CRITICAL CARE UNIT

PROPOSED LOADED FURNITURE PLAN

GROUND FLOOR CC AREA

CC(72)-01

PROPOSED LOADED FURNITURE PLAN
1:100

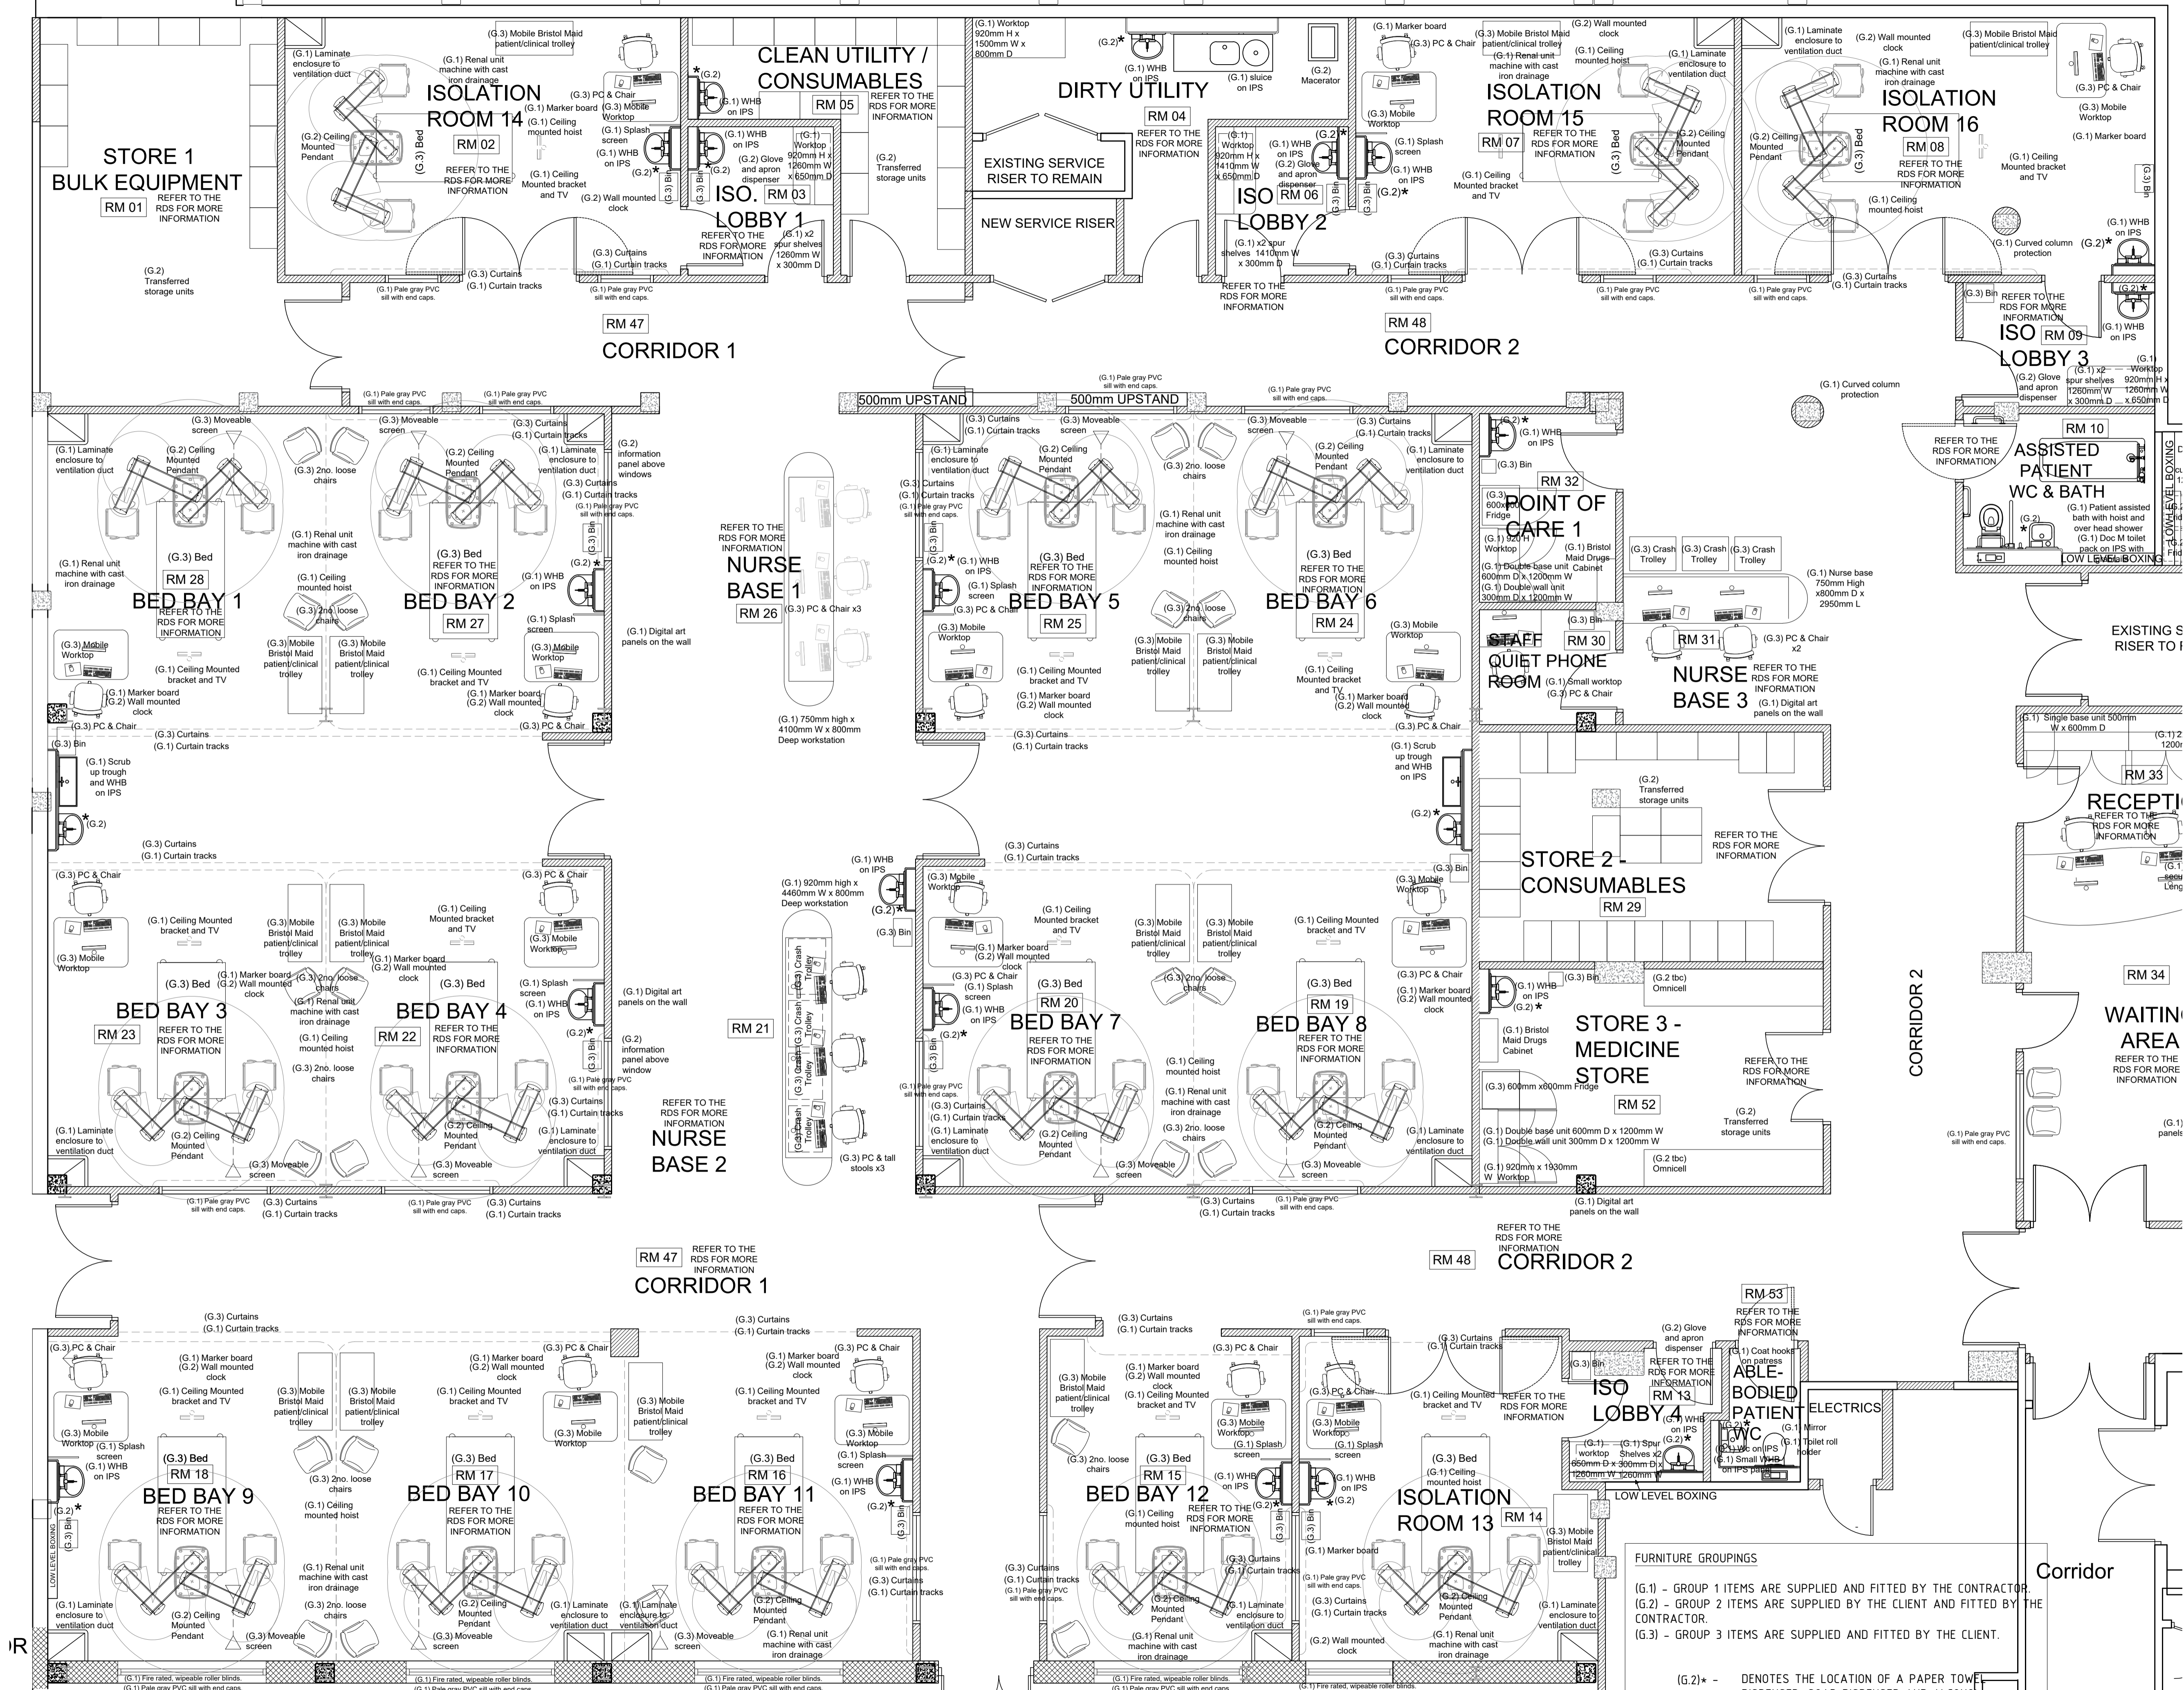
Notes	Status	Rev	Date
FEASIBILITY STUDY	F	-	27/04/2021
TENDER ISSUE	T	A	05/05/2021
AMENDMENTS:			
- Single door between the Iso Lobby 3 and Isolation Room 16 has been moved closer to the WHB			
- 900mm wide window has been added between the Isolation Room 16 and Corridor 2			
- Blinds have been removed from (G.1) double glazed internal window texts.			
- Storage units have been added to the rooms Store 1 - Bulk Equipment, Clean Utility/Consumables and Store 2/Consumables.			
Furniture text have been changed from (G.3) to (G.2).			
AMENDMENTS:	T	B	17/05/2021
- (G.1) Column protection added			
- (G.3) Curtains and (G.1) Curtain Tracks added			
AMENDMENTS:	T	C	18/05/2021
- Ceiling mounted pendants changed to (G.2) item. Patient and clinical trolleys omitted and replaced with an all in one, Bristol mobile trolley.
